GEOENGINEERS

Subject: Response to City of Portland BDS Site Development Checksheet dated November 5, 2019
Prologis Development at NE 158th Avenue and NE Airport Way
Portland, Oregon
File No. 3626-071-00

Figure 1. Revised Building and Preload Fill Footprint
Field Report 26 - 9/12/2019
Field Report 27 - 9/13/2019

FOR REFERENCE ONLY
Figure 1
Plan check 11.8.19
PERMIT SET - 1.4.19

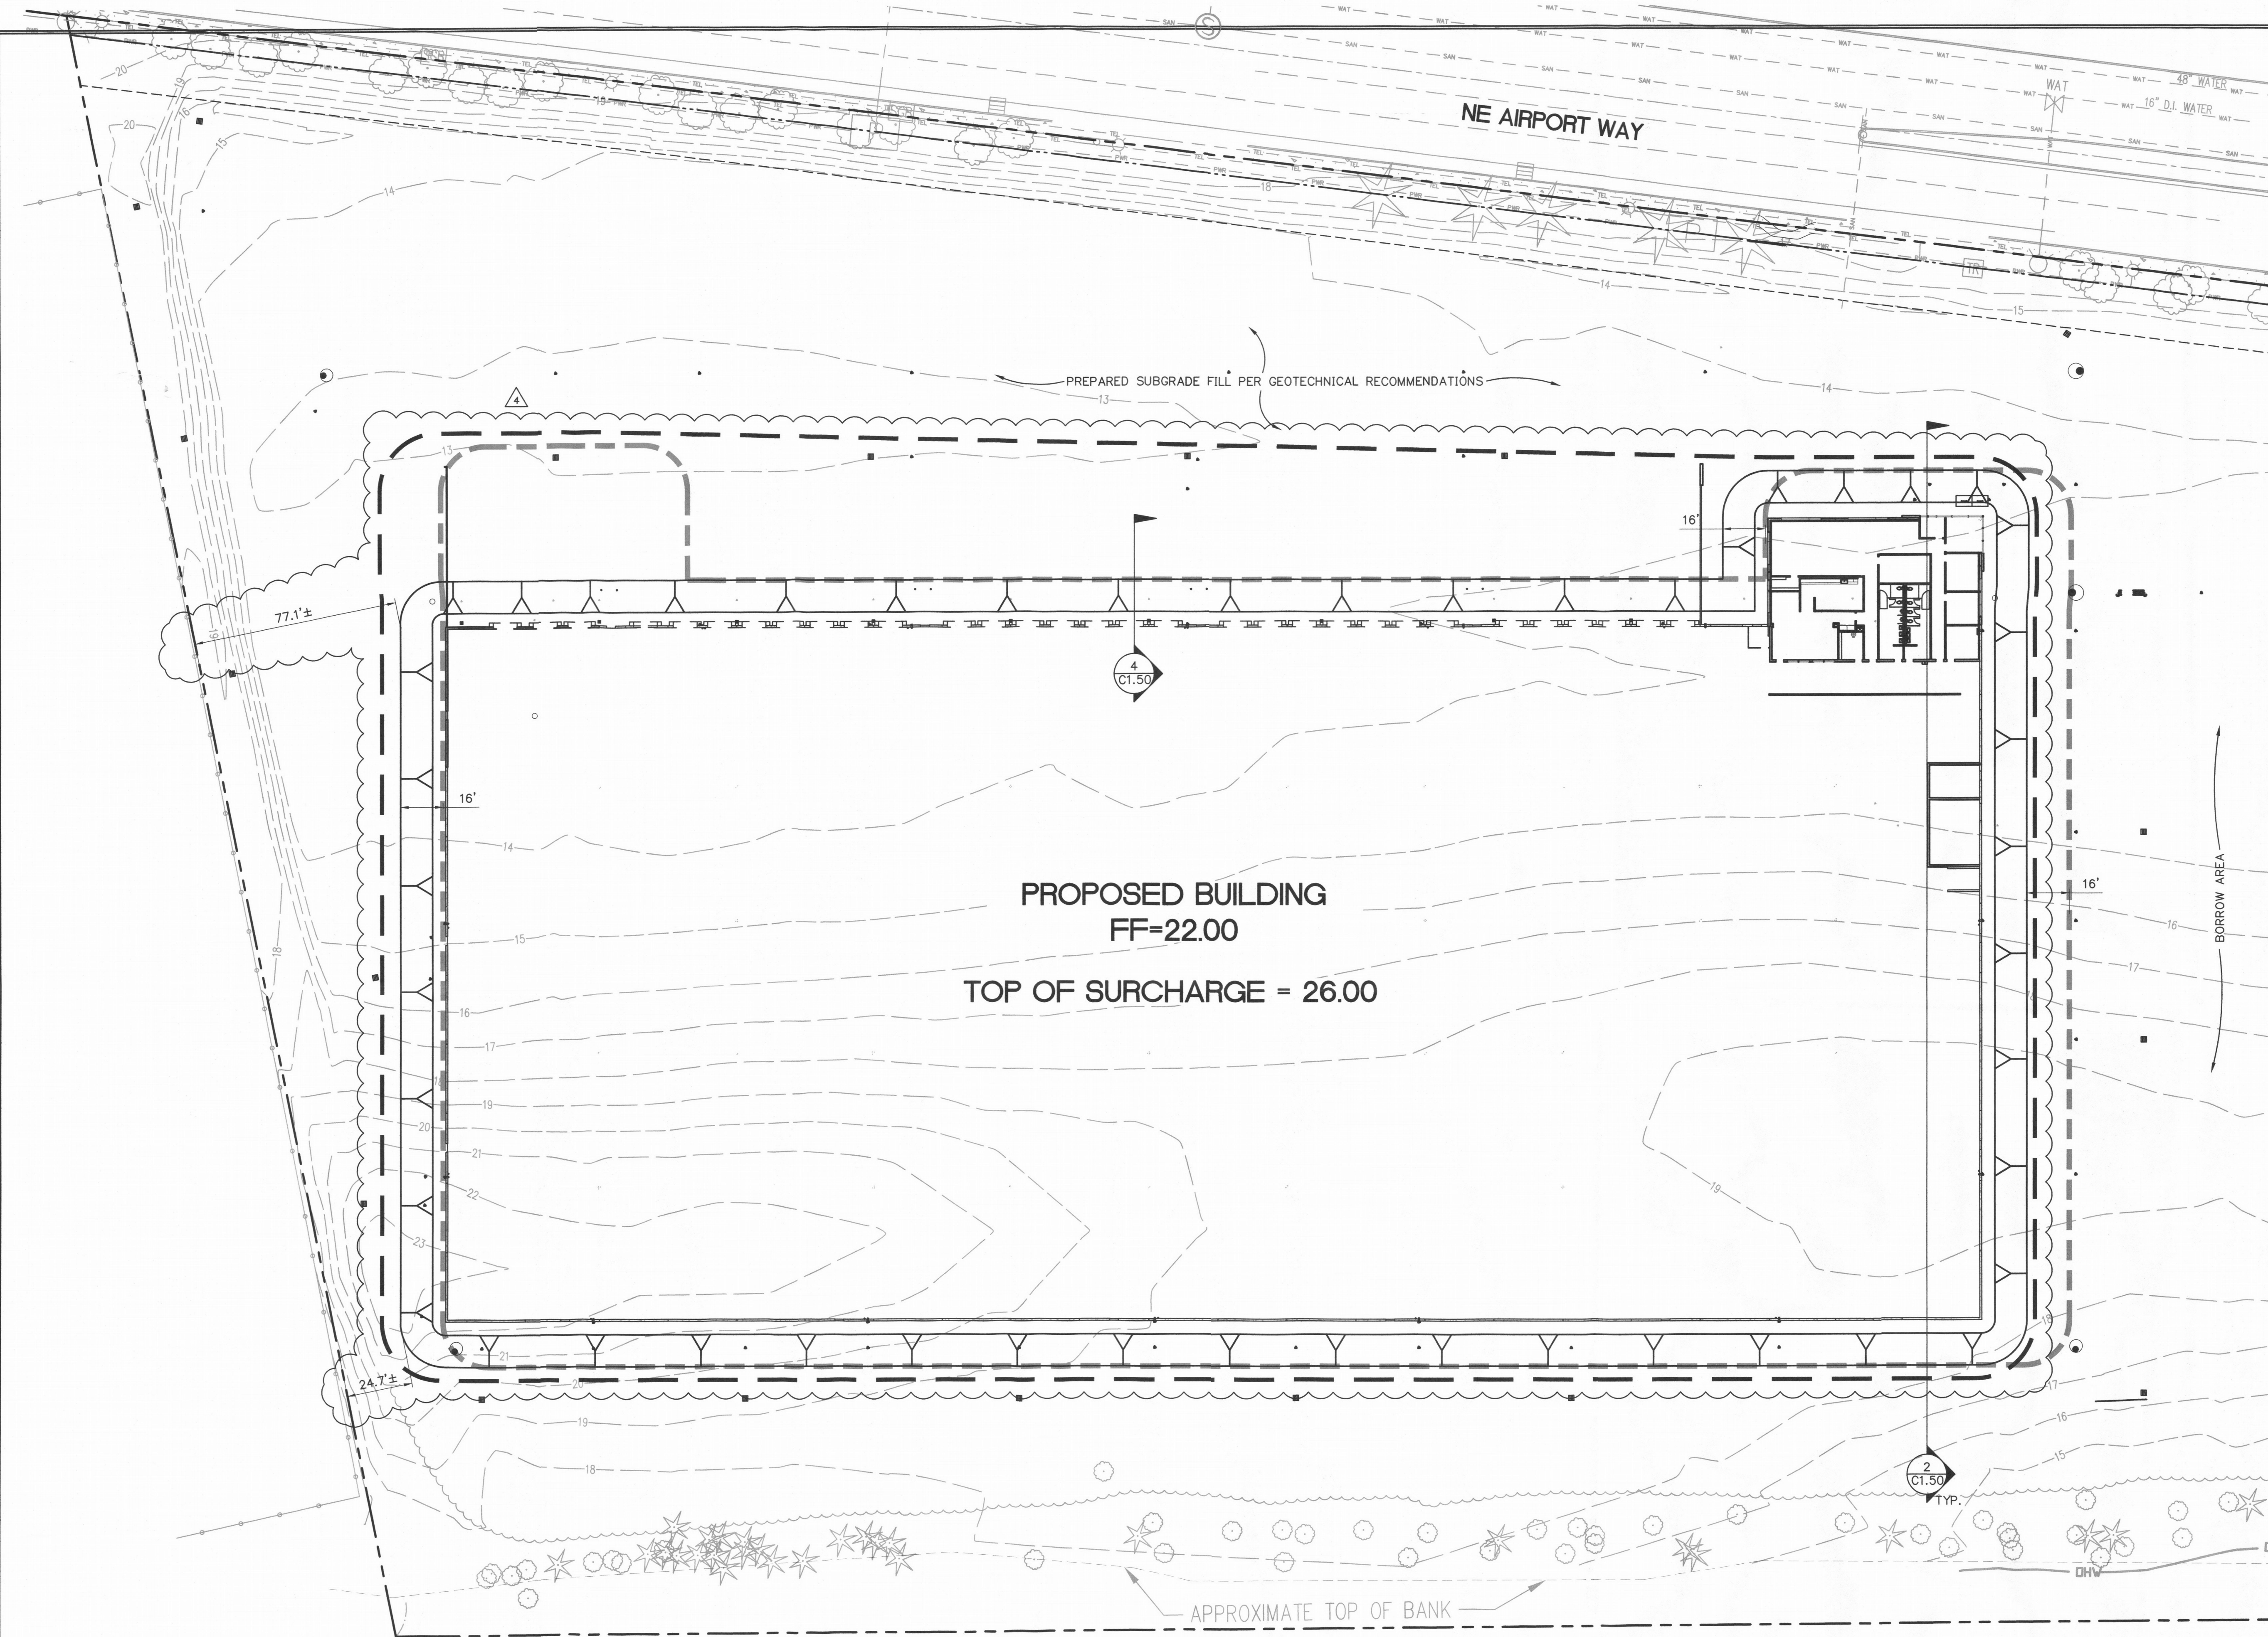
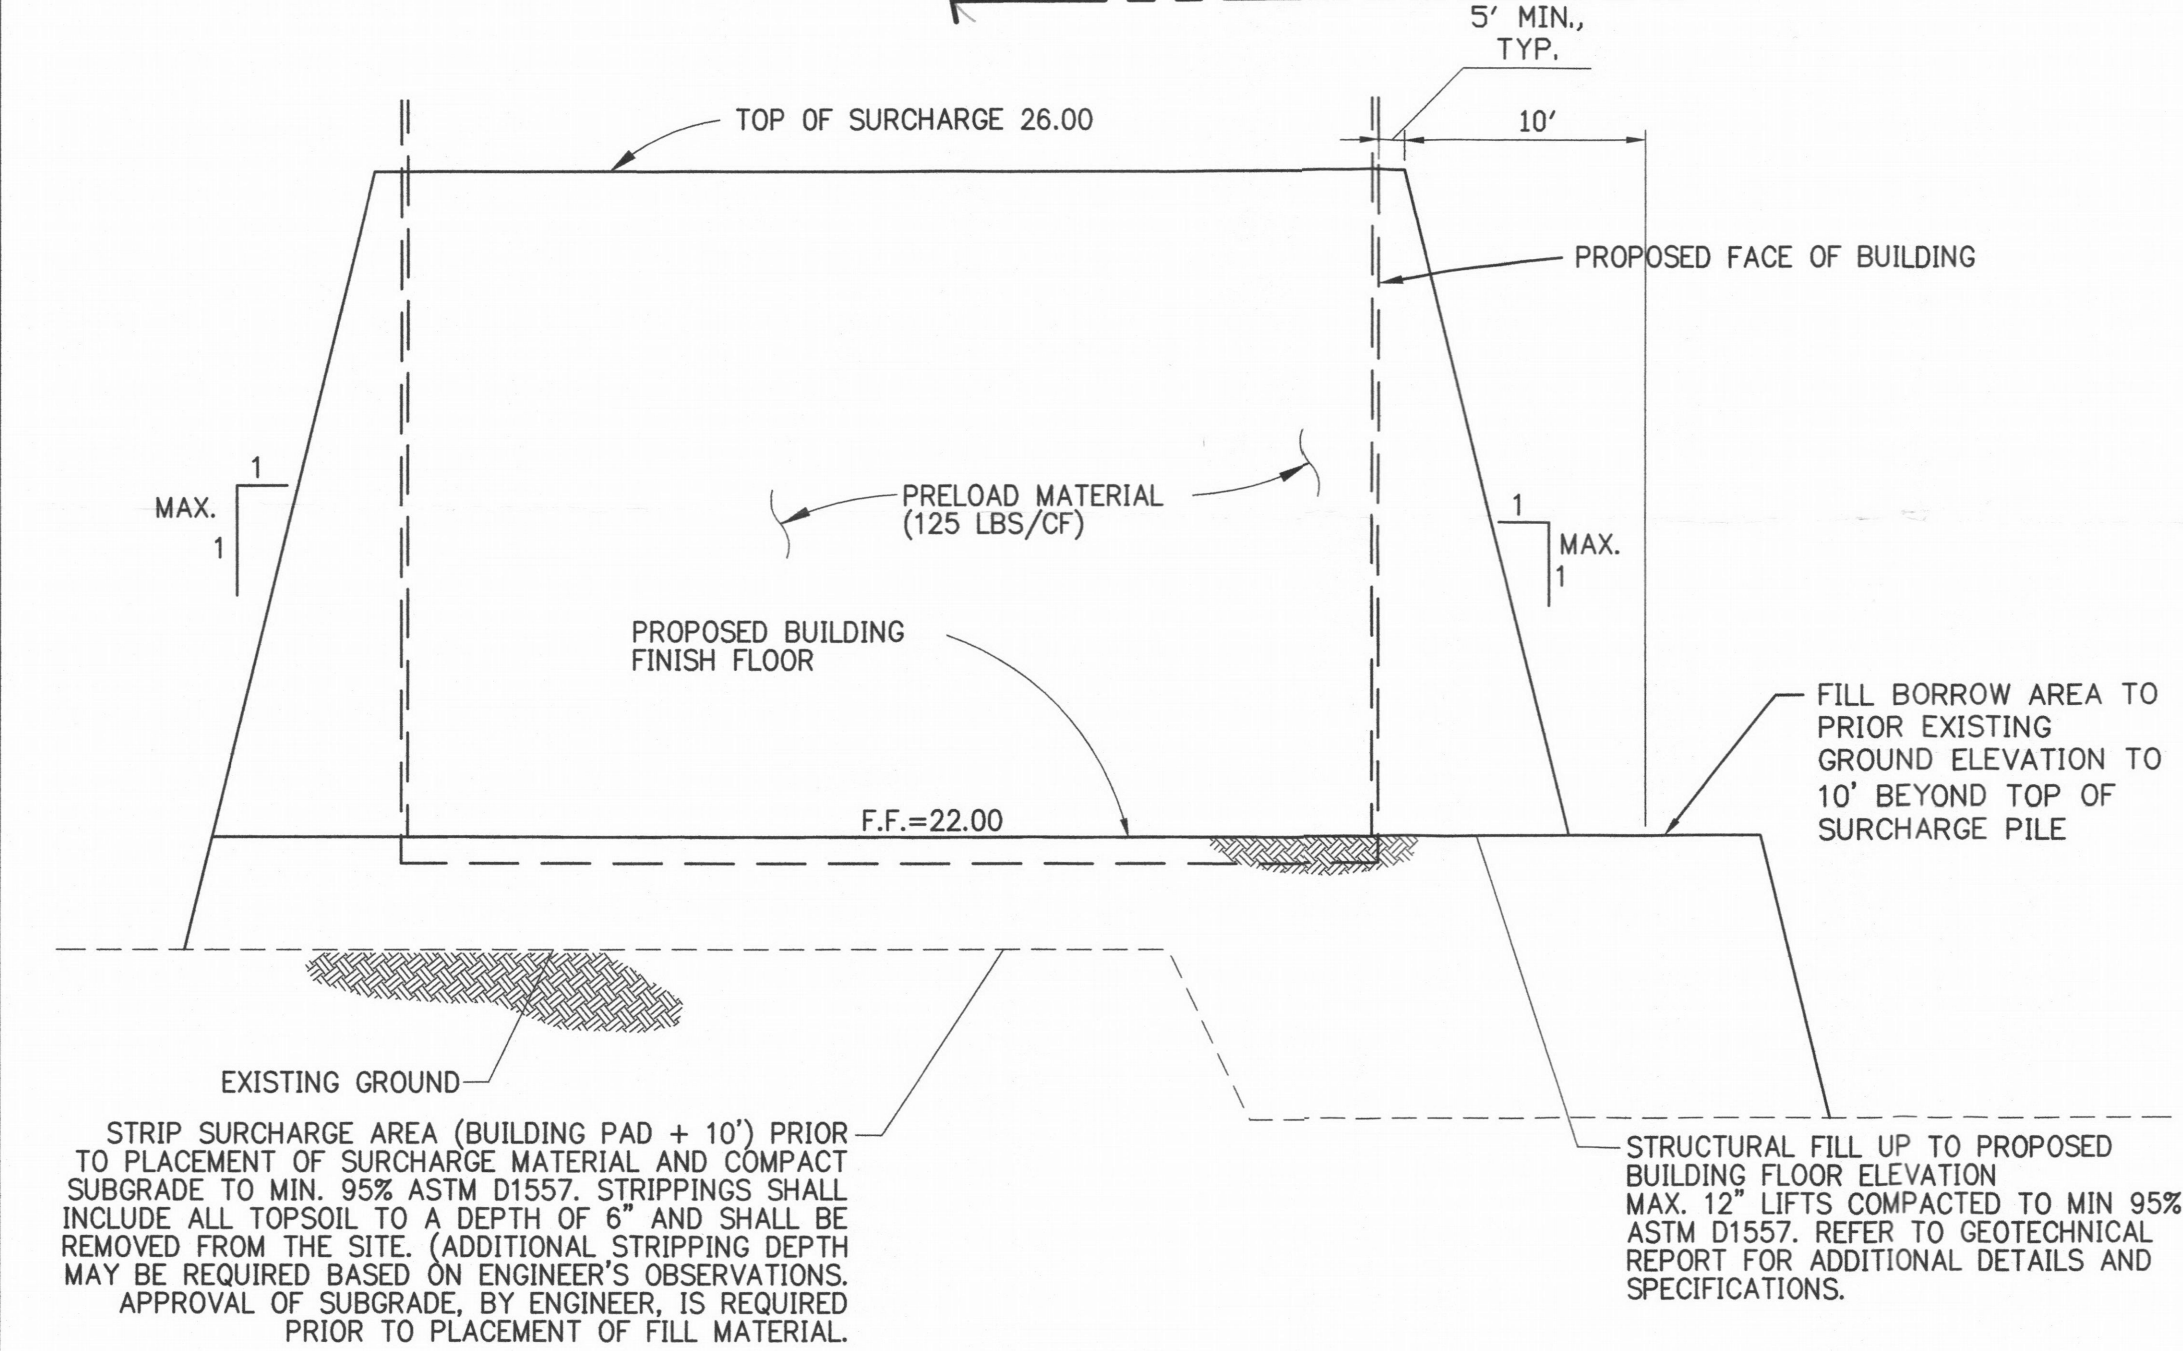
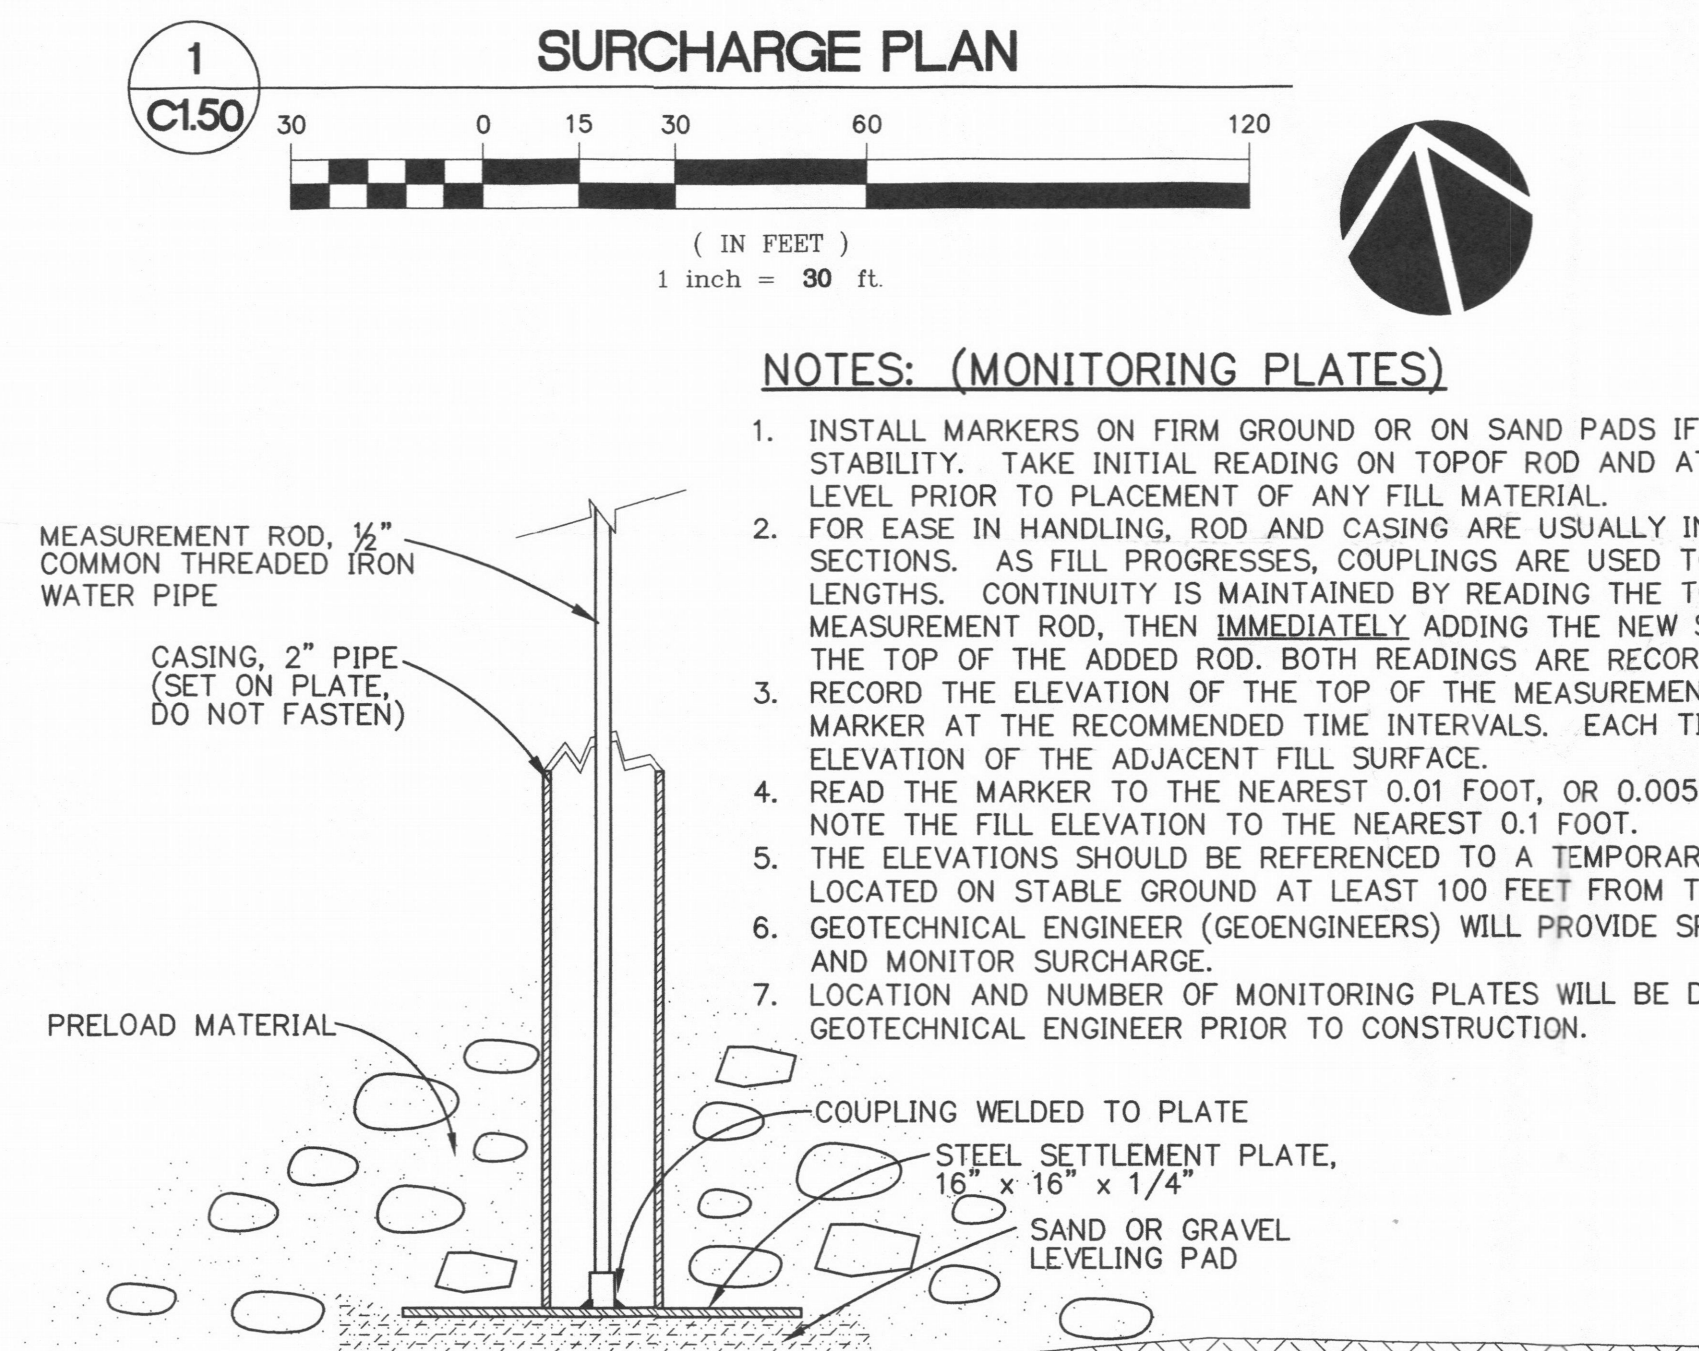
This letter respond to the checksheet correction items 1 and 2 provided by City of Portland Bureau of Development Services dated November 5, 2019. This letter is to acknowledge that GeoEngineers was aware of the revision to the proposed building footprint. We provided revised preload recommendations, and observed and evaluated the preload fill placed within the revised building footprint.

We understand that the proposed building at the site has been relocated approximately 16 feet west of its original location. Figure 1 presents the revised building footprint and the revised preload fill footprint constructed per our recommendations. We also completed two site visits to observe the preload fill placement within the revised building area west of the original building footprint. Our observations of the preload fill placement and evaluation are presented in the attached Field Reports 26 and 27, dated September 12 and 13, 2019, respectively. The settlement monitoring program developed and implemented for this project incorporated the revised footprint and therefore no updated preload summary letter is required.
